Product Change Notification

Product Line:	COMBO A	Part No:	NCJ6FA-*
Piece Part:	XLR contact	Part No:	91418511 91418521 91418531 91418561 91418571
Engineering Change Request:	-	Date:	-
Engineering Change Execution:	-	Date:	-
Comments:	XLR contacts changed to selective plating		
Affected products:	NCJ6FA-H, NCJ6FA-H-0, NCJ6FA-H-0-Y, NCJ6FA-H-D, NCJ6FA-H-Y, NCJ6FA-V, NCJ6FA-V-0, NCJ6FA-V-0-Y		
First Shipment of Modified Product:	H01

Engineering Change Notice

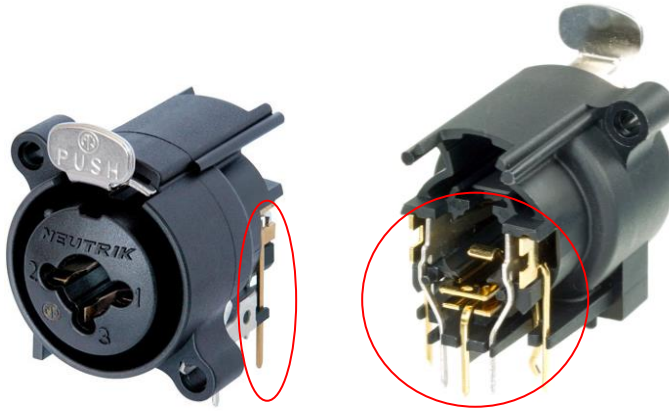
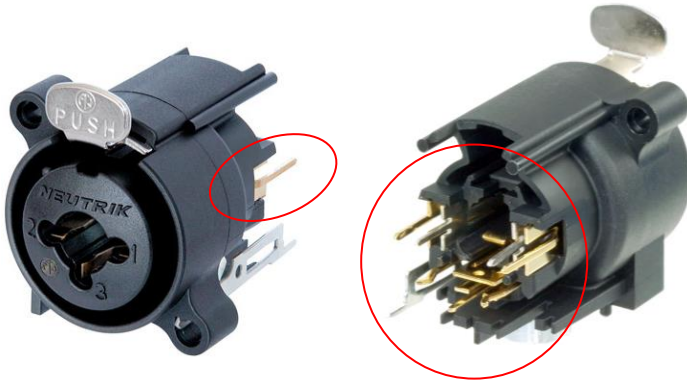
Plating changed from fully gold plated to selective gold plating at contact area and tin plating at PCB termination area for best conductivity and solderability.

XLR contacts
fully gold plated

XLR contacts
with gold plating
at contact area
and tin plating at
PCB termination
area
